SAFETY RECALL BULLETIN

SUBJECT: PASSENGER SUN VISOR – SAFETY RECALL CAMPAIGN		No: SR-15-005	
		DATE: July, 2015	
		MODEL: 2000-05 Eclipse and Eclipse Spyder	
CIRCULATE TO:	<input checked="" type="checkbox"/> GENERAL MANAGER	<input checked="" type="checkbox"/> PARTS MANAGER	<input checked="" type="checkbox"/> TECHNICIAN
<input checked="" type="checkbox"/> SERVICE ADVISOR	<input checked="" type="checkbox"/> SERVICE MANAGER	<input checked="" type="checkbox"/> WARRANTY PROCESSOR	<input checked="" type="checkbox"/> SALES MANAGER

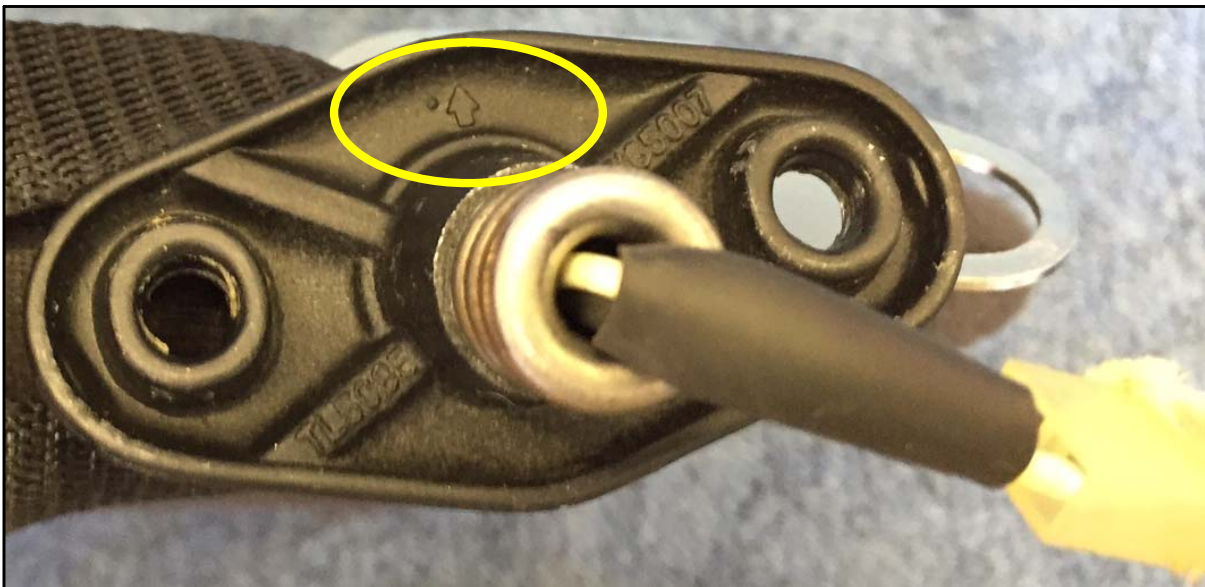
- a. Place the tether strap's mounting bracket reinforcement strap around the sun visor's mirror light harness connector (1) (if equipped) and sun visor's mounting bracket (2), eventually coming to rest on the sun visor.

- b. Place the tether strap's reinforcement bracket (silver finish) over the sun visor's mirror light harness connector (if equipped) and onto the sun visor's mounting bracket.

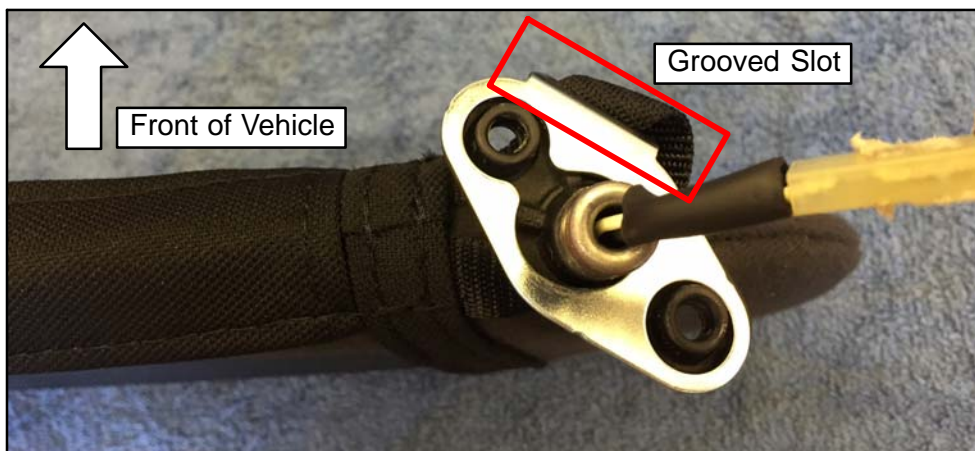
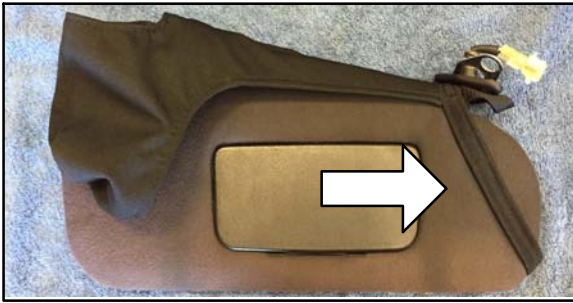
- c. Rotate the sun visor's mounting bracket in a position where the arrow inside the mounting bracket is pointing towards the front of the vehicle.

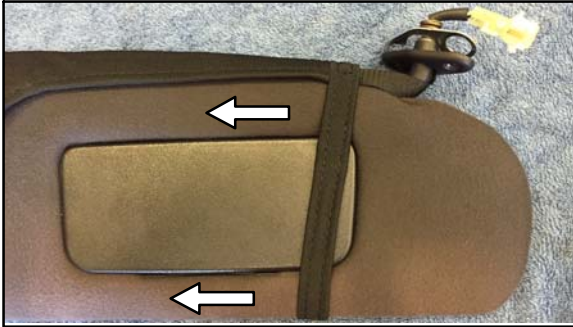
- d. Mount the tether strap's reinforcement bracket (silver finish) on top of the sun visor's mounting bracket. The tether strap's reinforcement bracket (silver finish) has a grooved slot that seats over the mounting bracket and indicates the mounting bracket's position during sun visor re-installation (grooved slot must be facing towards front of the vehicle).

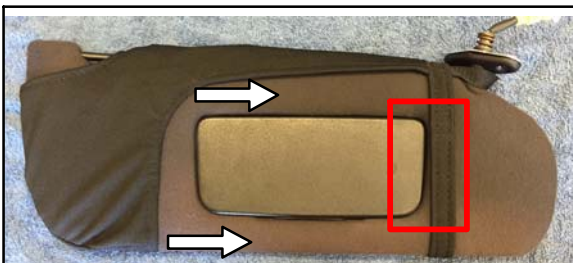
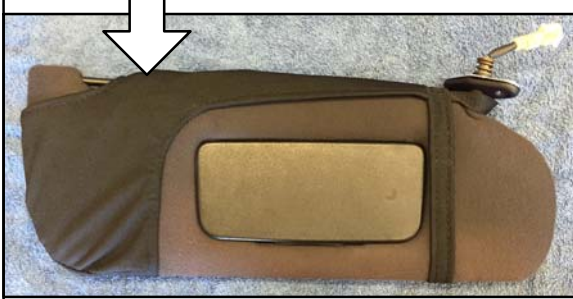
- e. Install the right portion of the tether strap over the right side of the sun visor.

- f. Pull the right portion of the tether strap across the sun visor in the direction indicated. Doing this provides additional slack to install the left portion of the tether strap.

During tether strap install on the right side of the visor, do not damage the tether strap or the sun visor. Be careful, patient, and gentle during installation. The tether strap is designed to be a tight fit over the sun visor.

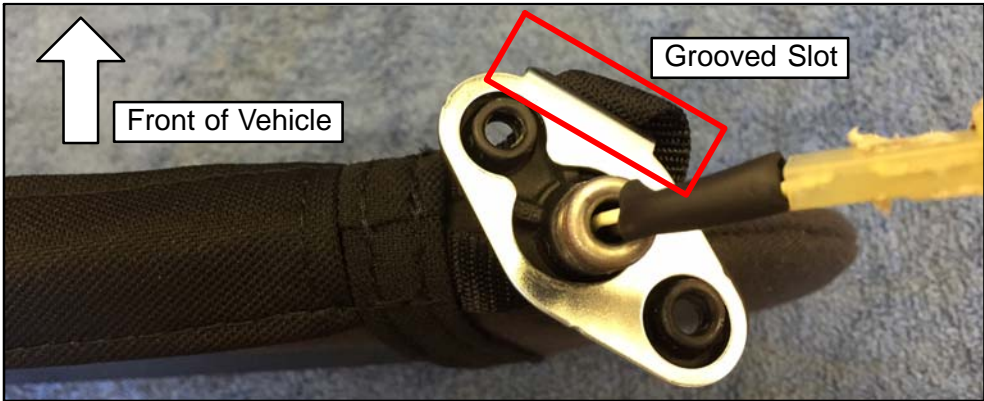
- g. Install the left portion of the tether strap over the left side of the sun visor.

- h. Pull the tether strap in the direction indicated to center the tether strap. Adjust the tether strap so it correctly fits over the sun visor and ensure the strap does not block the mirror cover from opening.
- i. Ensure all warning labels on the back side of the sun visor are still visible.

Ensure the grooved slot of the tether strap's reinforcement bracket (silver finish) is facing towards the front of the vehicle during passenger sun visor re-installation.
